Car Stereo Service Bulletin

Model: MDX-40/400

No. **376**

Subject: Skipping.

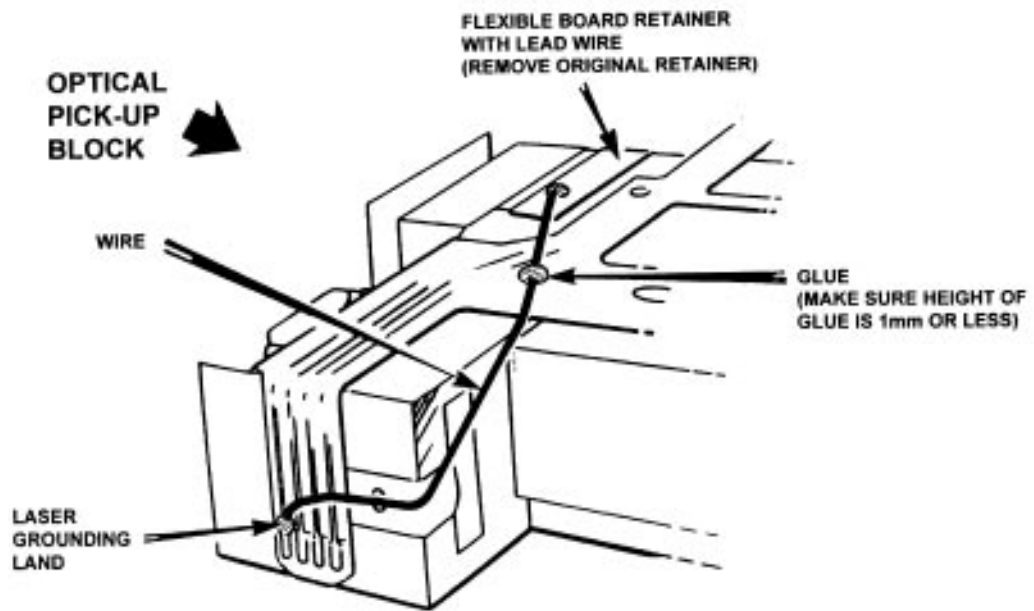
The unit skips while playing recordable or pre-recorded discs

If the customer complains of these symptoms, implement the changes shown below.

REF	DESCRIPTION	PART NUMBER
-	RETAINER	3-916-086-01

- 1- Remove and discard the retainer which secures the flex cable to the optical pickup block.
- 2- Clean the area from which the retainer was removed with alcohol.
- 3- Install the new retainer which includes a lead wire.
- 4- Secure the lead wire with a small amount of glue as shown. **Be sure to keep the height of the glue droplet to 1 mm or less.**
- 5- Dress the lead wire snugly along the top of the optical pickup block and down the side as shown.
- 6- Solder the lead wire to the laser ground trace on the flex cable as shown.
